**CVL Network – CVL Network Code Condition G1 Network Change Proposal:
Tir-Phil Station Operational Platform Length Change (Dn Platform)**

Appendix A – Proposal Tir-Phil Station Operational Platform Length Change (Dn Platform)

Annex 1.1 - Extracts from Drawing number TRAN01-KAW-R5_RHY-DDR-C-CV-000114

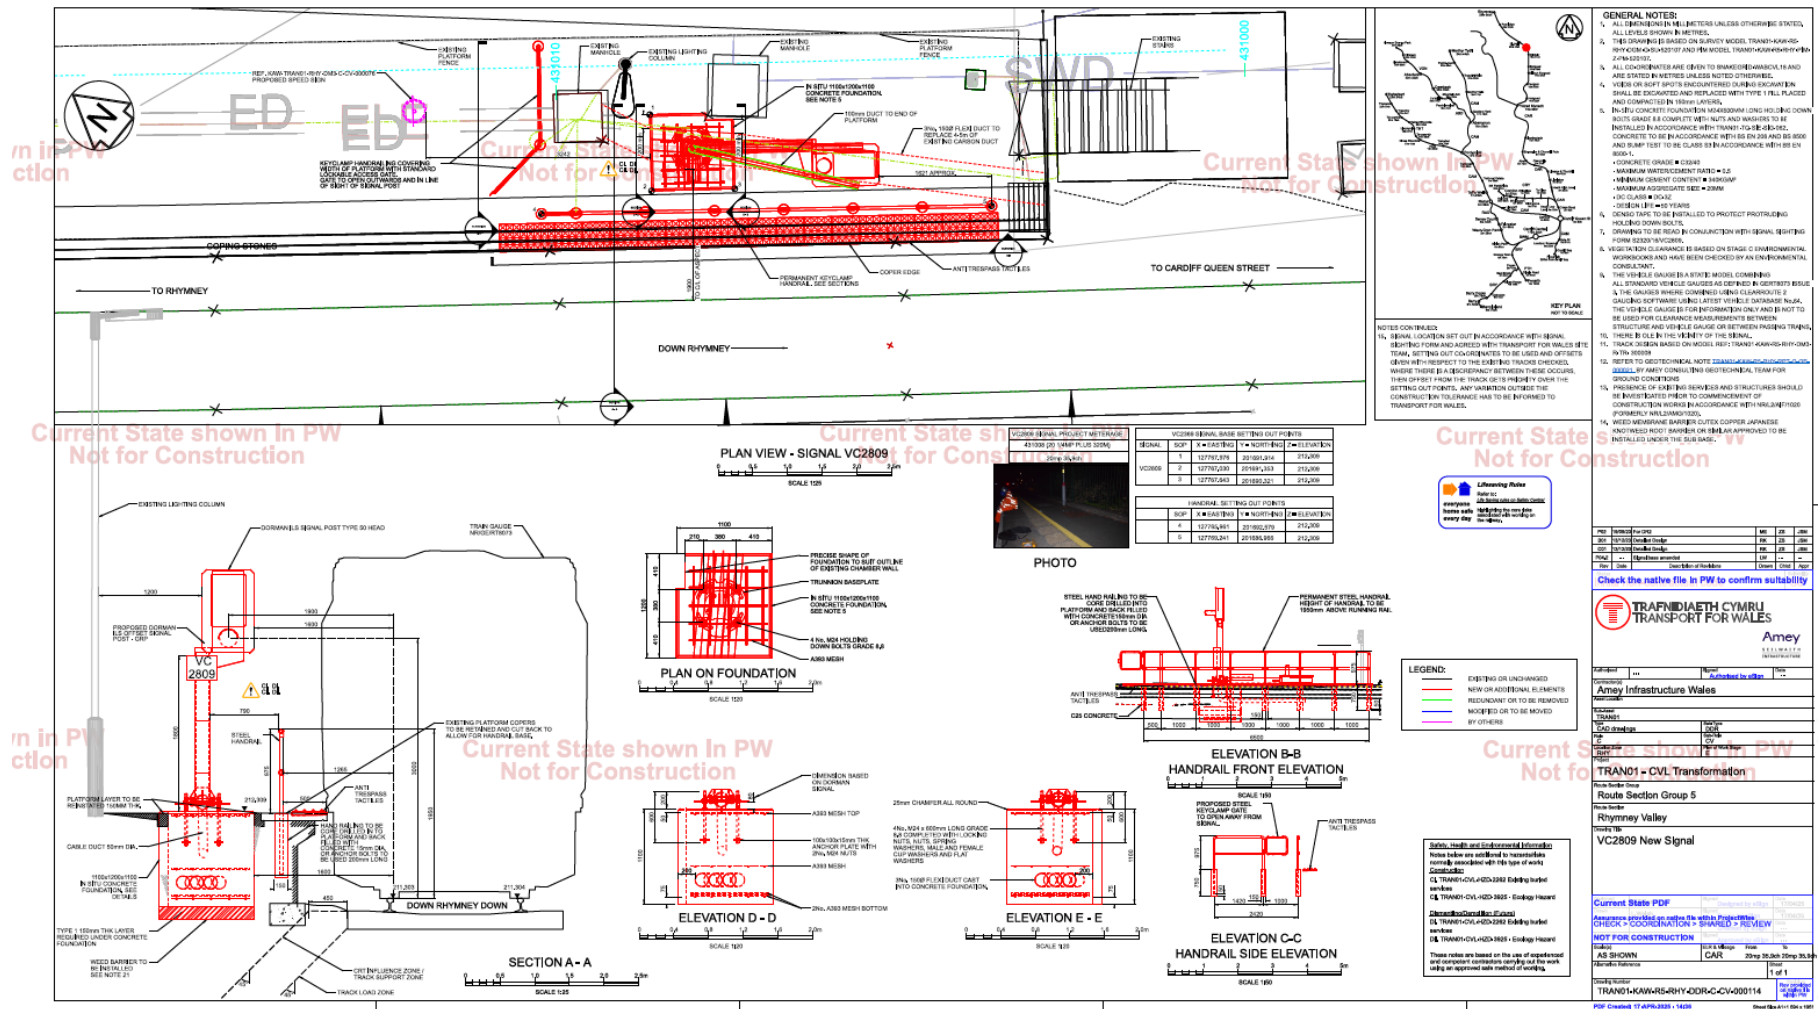
As part of the CVL Transformation programme and the requirement to support the introduction of new electric rolling stock on the CVL Network, there is a requirement to install new signal VC2809 (Dorman ILS Signal post type 50 head) on the down platform at Tir-Phil to correct an existing sighting issue.

As a result of the installation of this signal on the Dn platform there will be a reduction in platform length of 8mtrs due to the installation of signal and associated fencing and anti-trespass guards required.

The planned reduction in platform length is from 124mtrs to 116mtrs.
